SERVICE BULLETIN

RMD 8501, RMD 8505, RMD 8551, RMD 8555, RMDT 8501, RMDT 8505, RMDT 8551, RMDT 8555

Problems with condensation

1. Condensation around the operating panel

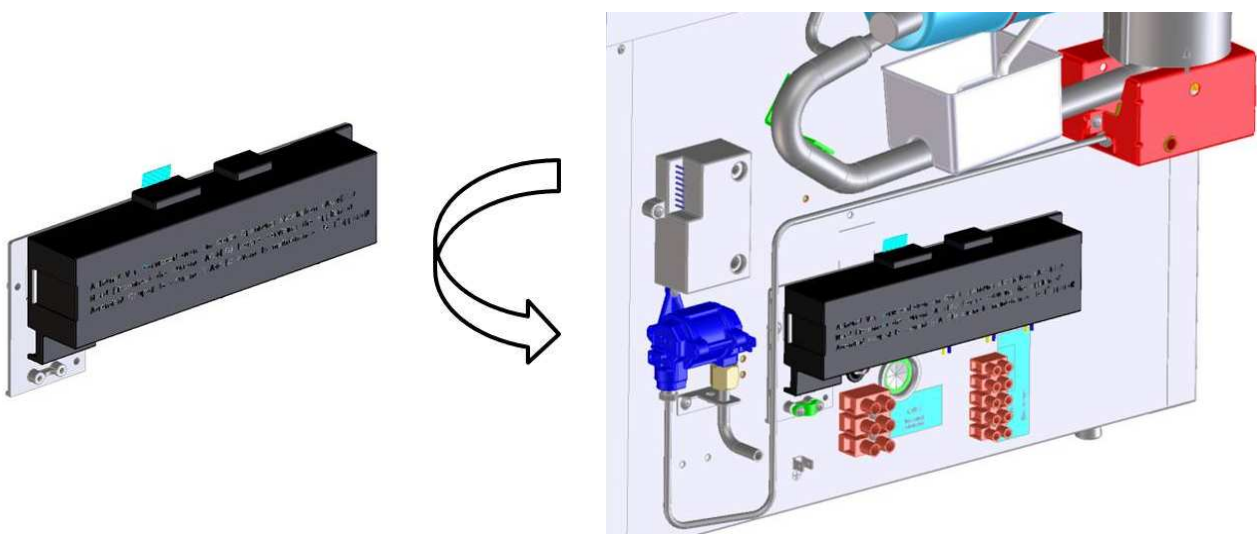
In case of condensation around the operating panel please install the following service kits:

These service kits comprise the new electronics 289 0347-03/8 for MES or 289 0347-13/7 for AES (frame heating is not switched off automatically after two hours), an insulating seal for the freezer compartment door 293 5688-21/4 and an instruction 210 6513-54/8.

The electronic is programmed to switch on the frame heating automatically whilst operation on 12V and mains and to allow switching on or off the frame heating manually whilst gas operation.

289 0347-02/0, RMD/T 85x1
289 0347-12/9, RMD/T 85x5

2. Condensation on the freezer compartment door around the lock

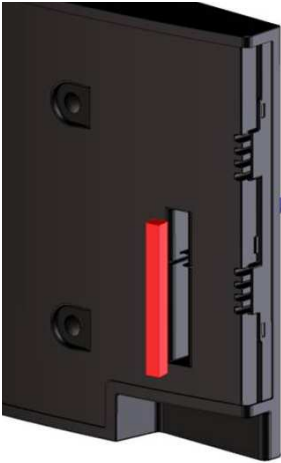
Mounting the insulating foam strip 293 5688-21/4.
Please read the service bulletin 599 7471-57.
